ADDENDUM NO. 2

SUBJECT: Addendum No. 2 to the RFP for Zero Emission Electric Bus Solution

EXHIBIT 1

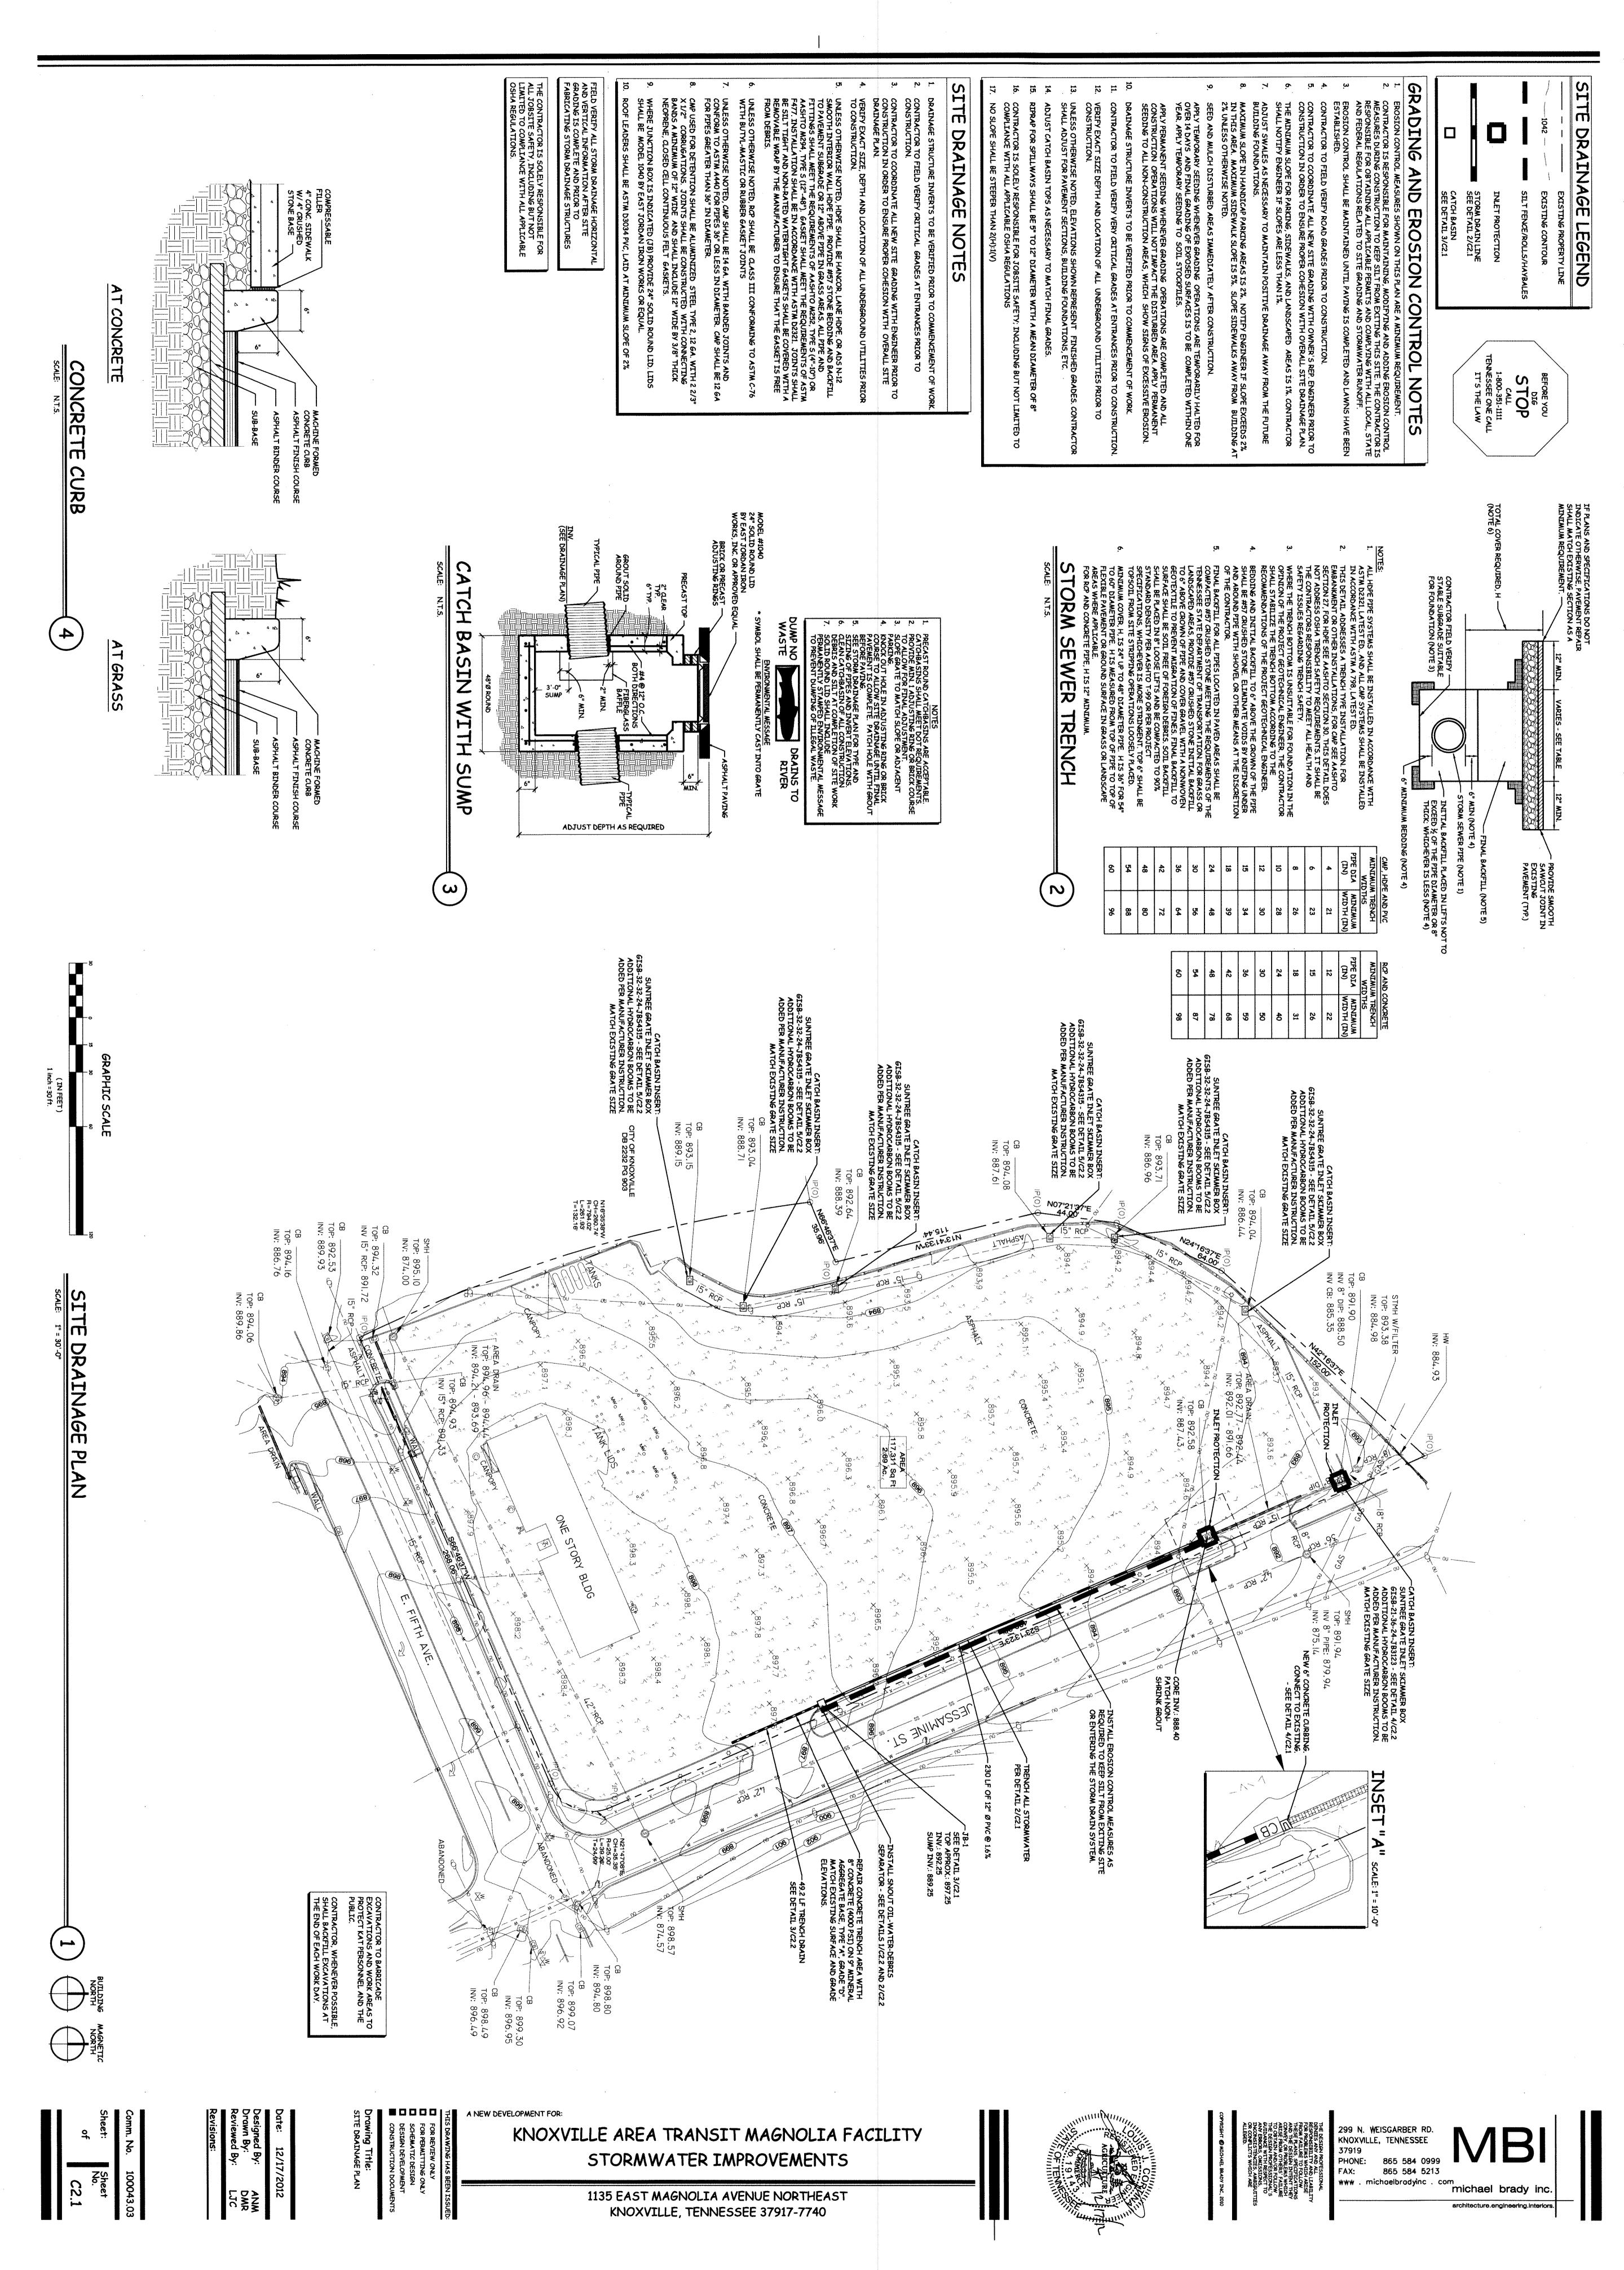
ITEM #3: The picture in Exhibit 1 of this addendum depicts planned location of the bus lot utility grid transformer and its proximity to electric bus parking spaces. Exhibit 2 to this addendum provides a scaled bus lot sight plan used during a recent stormwater drain system improvement project.
